ADDENDUM NO. ONE (1)

Date: 10/2/2026 PPI Project No. P26-106

Project: 2026 Grayson Road Resurfacing Program II: Contract # 27-01 Wilshire, Windsor Creek & Grayson Parkway (S.R. 84)

Client: City of Grayson

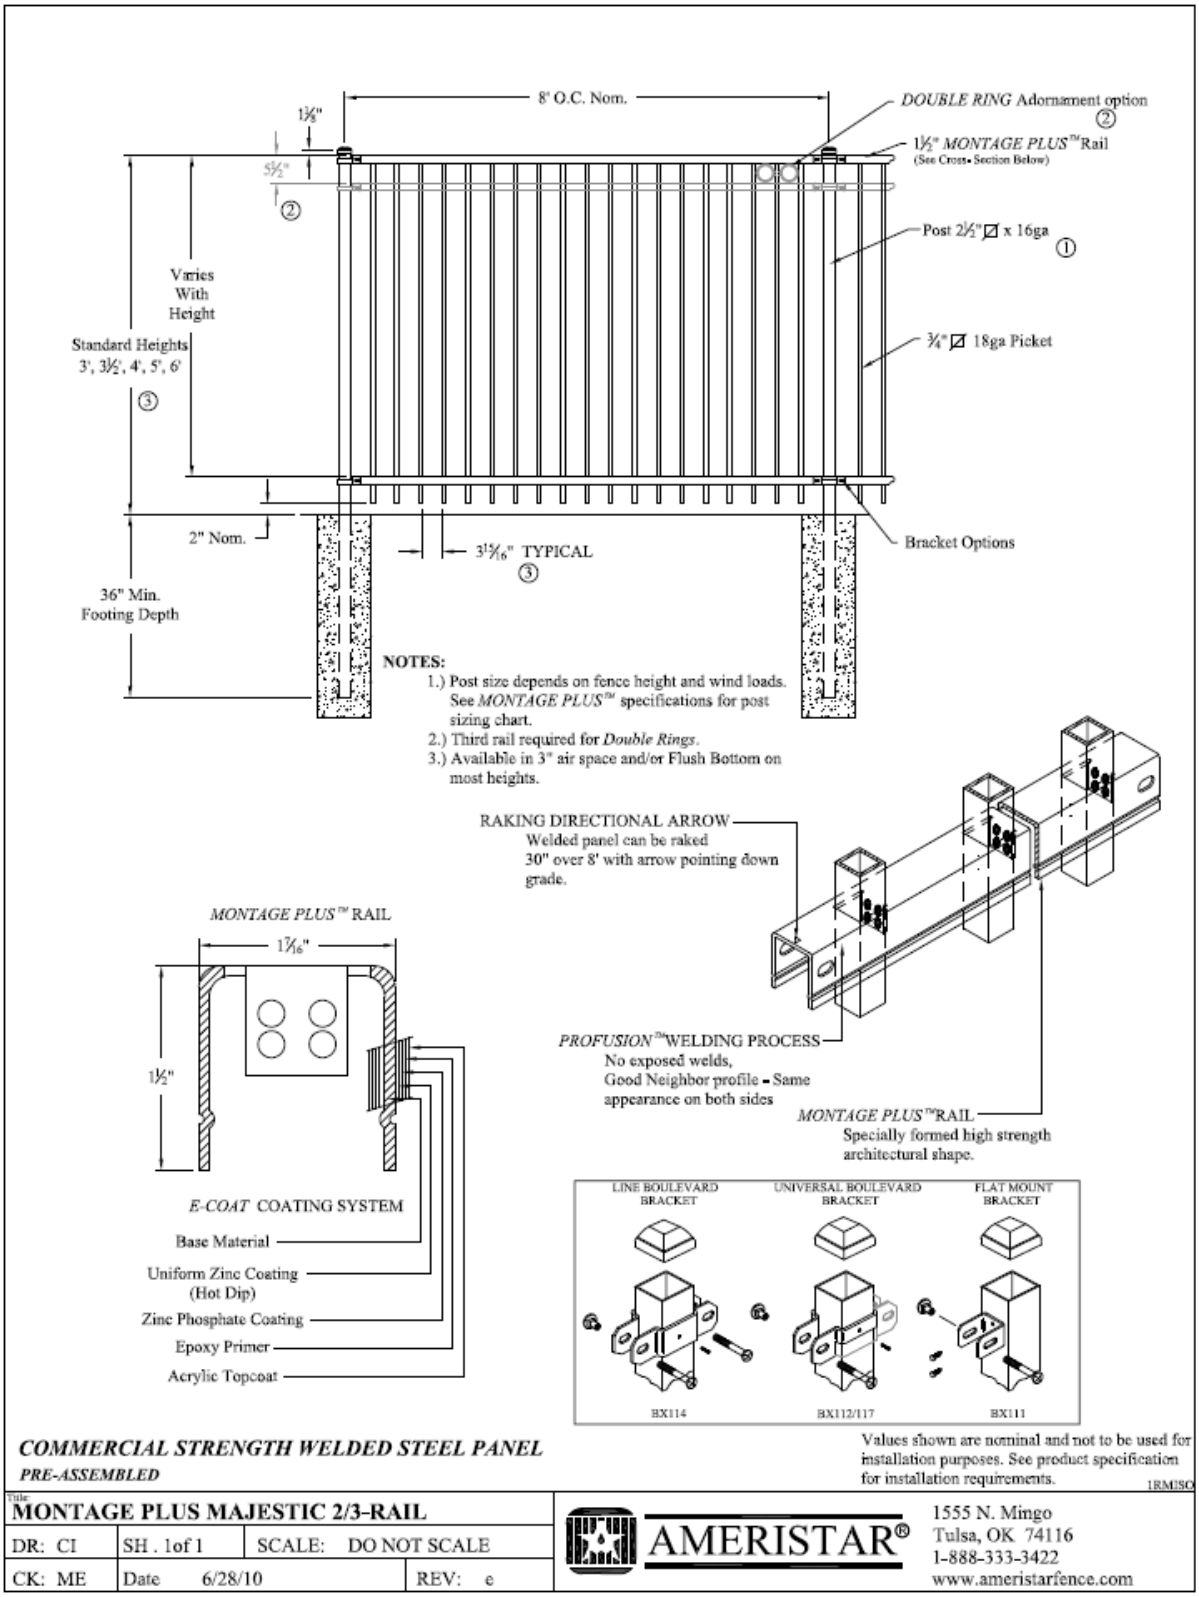
Q9. Is there a detail available in regards to the 42IN Decorative Railing for the Permanent Road Closure along Grayson Parkway?

A9. Decorative railing shall be Ameristar Montage Plus or equivalent

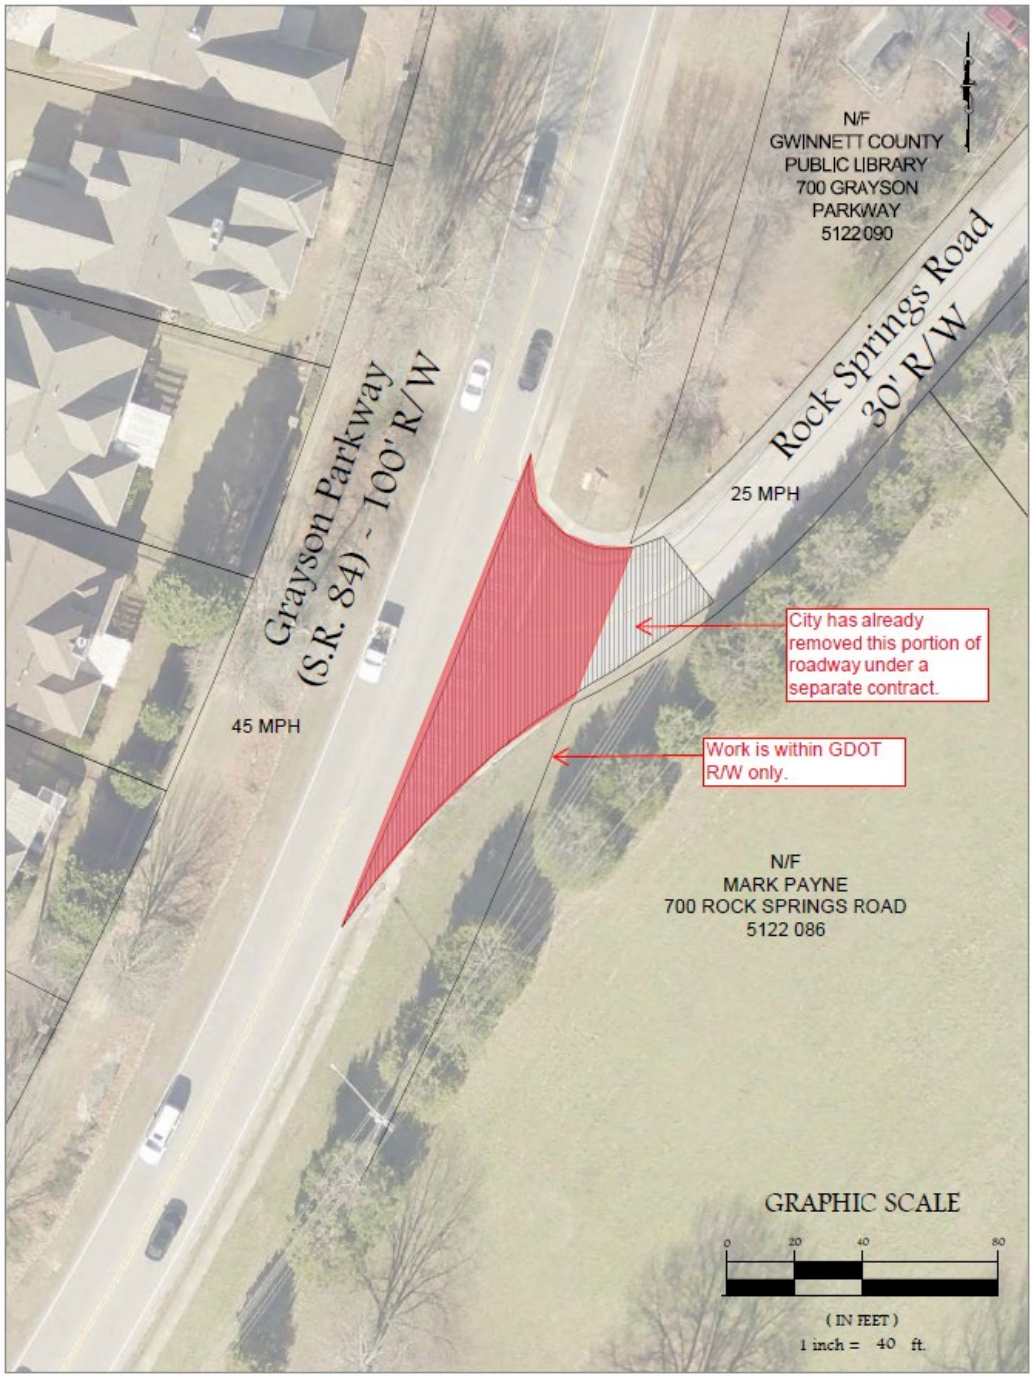
Q10. Can you provide an aerial map that shows where each scope on Grayson parkway will be performed?

A10.
